Report Title: Cuckmere Estuary: Draft Flood Risk Management Strategy –

**Consultation by the Environment Agency (EA)**

Report To: Cabinet Date: 21 November 2007

To respond to the EA's consultation document on the future of the Cuckmere Estuary.

# Мар В

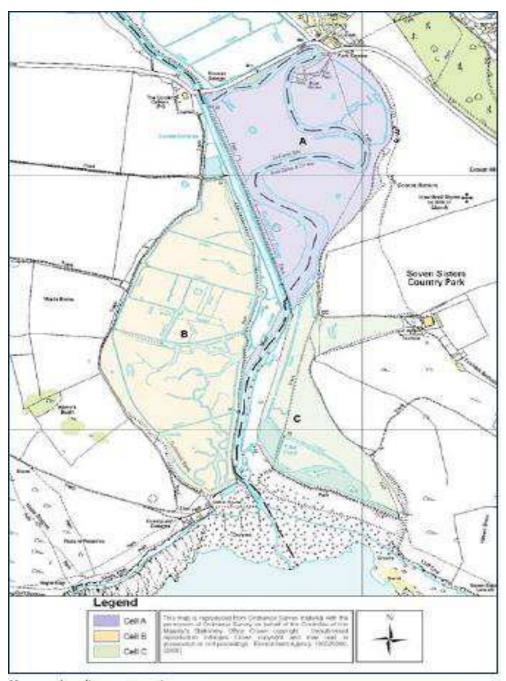
- 3.6 Options 3A and 3B score best for people and the environment in the Strategic Environmental Assessment carried out for the Environment Agency. However (as with Options 2A and 2B) these options are relatively costly (approx. £3.6 millions and £2.9 millions whole life costs, respectively) and would be unlikely to attract Government flood risk management funding. The EA state that they cannot pursue these options through a flood risk management strategy alone; they would need to work with partners (such as Natural England, National Trust, South Downs Joint Committee, East Sussex County Council, Lewes DC and Wealden DC) to identify other potential sources of funding to allow the managed realignment options in Options 3A and 3B to be pursued further.

- 3.7 Of the two options, Option 3A is preferred as it has less impact on public access and maintains the famous Cuckmere meanders (albeit requiring eventual de-silting) alongside creation of new intertidal habitats.

- 3.9 Cabinet is asked to consider which of the various options it wishes to support. On the basis of the information provided so far, particularly the need to respond to climate change and to work towards a naturally functioning river estuary which does not burden future generations with large ongoing flood defence maintenance costs, officers recommend either Option 1B or (if a more comprehensive funding package can be assembled by local partners) Option 3A.
